From: Griffin, Tim (Contractor)
Sent: 26 February 2026 10:25
To: Osmond, Gary
Cc: Oliveira, Marta (Contractor); Dyer, Tim; Ellison, Mark
Subject: Application No: F/26/100809 The Orchard, 5 Westgate Mews, Southampton - landscape comments

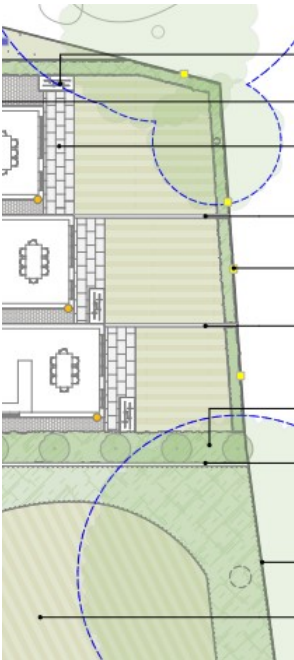
b/ Access drive - whilst I defer to the Highways and Urban Design Officers, it would appear that the current access is narrow and the additional traffic generated with 8 new houses would significantly impinge on the existing houses in Westgate Mews.

I also wonder if the proposed layout has been tracked, since some of the internal bends look rather tight, especially for refuse vehicles.
